ADDENDUM NO. 2

RE: **Addendum No. 2**
Metropolitan Topeka Airport Authority
Reconstruct Lower Taxiway Alpha-Delta
Topeka Regional Airport
AIP Project No. 3-20-0113-047

This addendum forms an integral part of the Contract Documents and modifies the original Contract Documents dated January 16, 2024, as noted below. Each bidder must acknowledge the receipt of this addendum in the space provided on the BID FORM. **Failure to do so may subject the bidder to be disqualified from bidding.**

SHEET NUMBER **CE5.01**

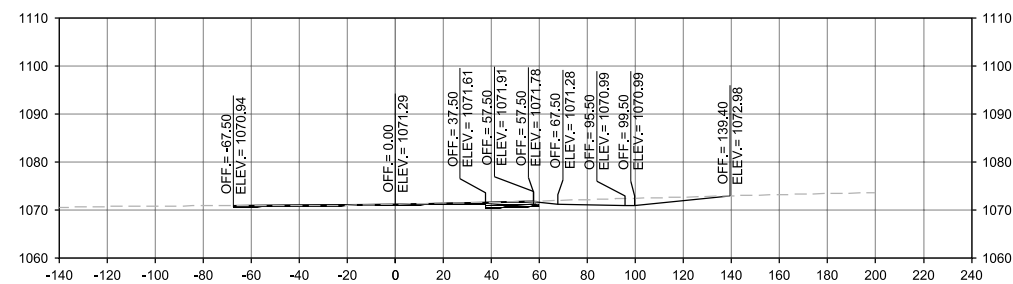
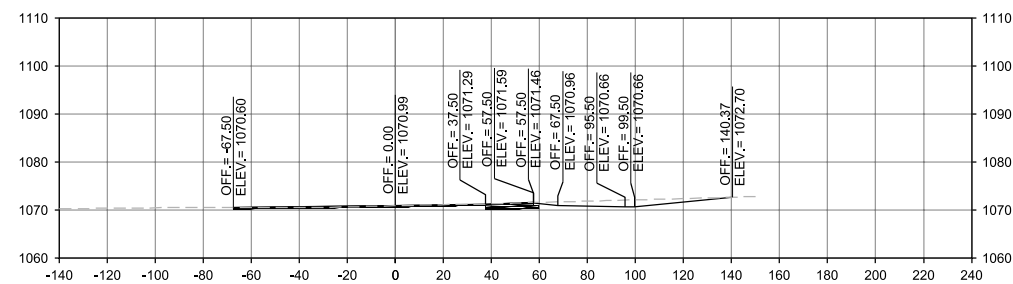
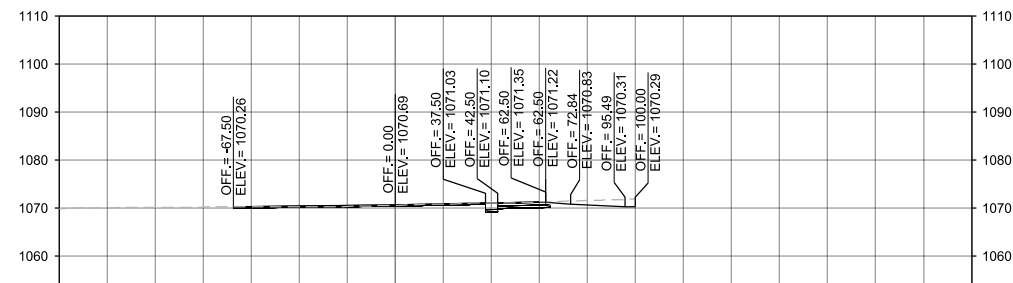
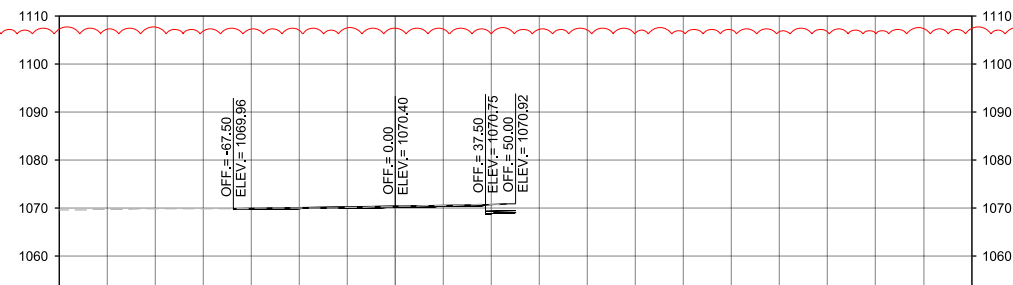
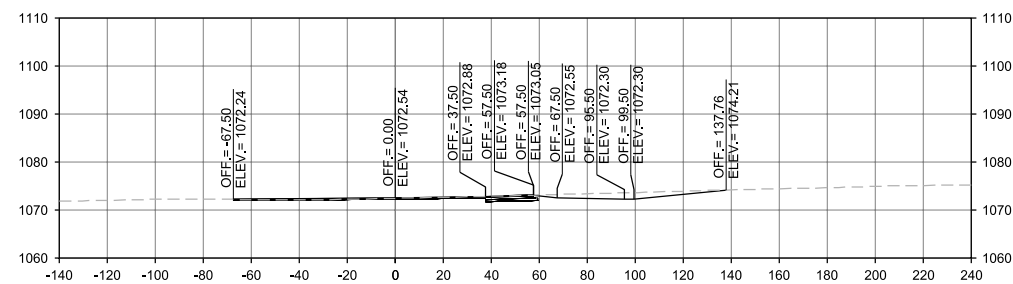
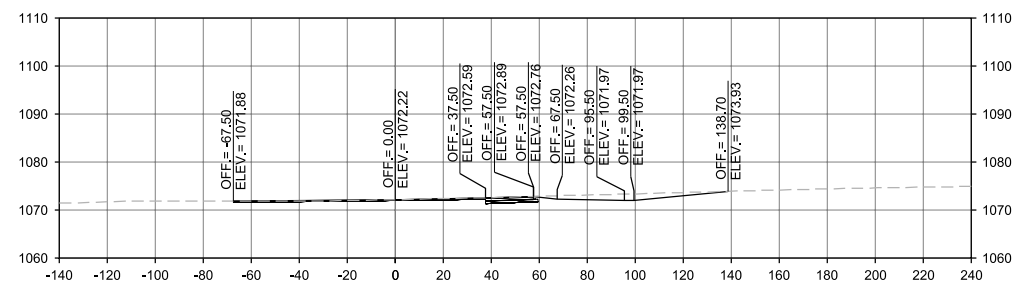
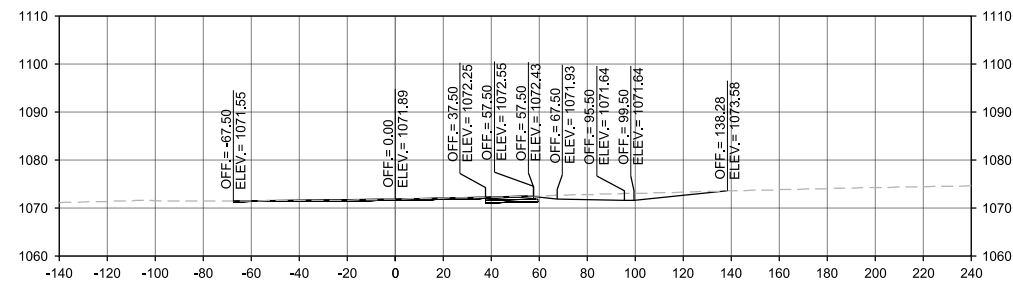
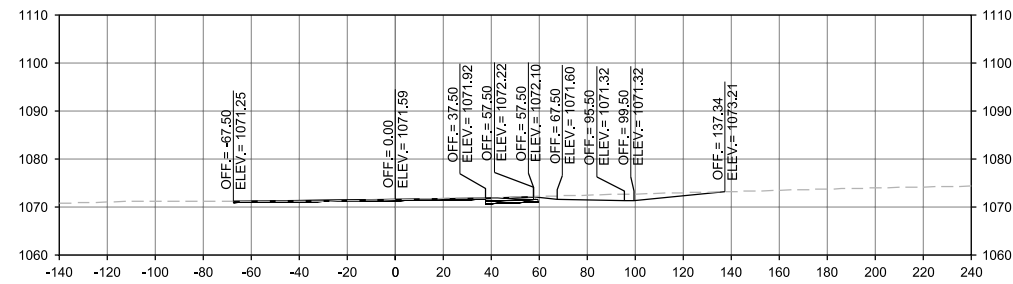
- A6.** Type D Pavement Removal has been added to the Proposal and the P-101 Specification.
- Q7.** On Sheet CE5.01 we have the following questions.
1. The type of Temporary Fertilizer is not provided.

2. The Acres shown is 42.85 which does not match the Bid Quantity of 21 Acres.
 3. The schedule seems to indicate that hay mulch would be used since Mulch Tacking Slurry is shown. This conflicts with Item T-908 which states that hydraulic mulch shall be used.

- A7.** Temporary fertilizer shall be the same as shown in T-901-2.3, 12-12-12. Sheet CE5.01 has been revised.
- Q8.** We are having trouble reconciling some of the underdrain outlet quantities. Using the information provided on Sheet CG5.01. We assume the Laterals are the non-perforated pipe. However, we get a total of only 174.47 feet instead of the Bid Quantity of 450 feet. We can only find 24 cleanouts on the Plan Views as opposed to the Bid Quantity of 28.
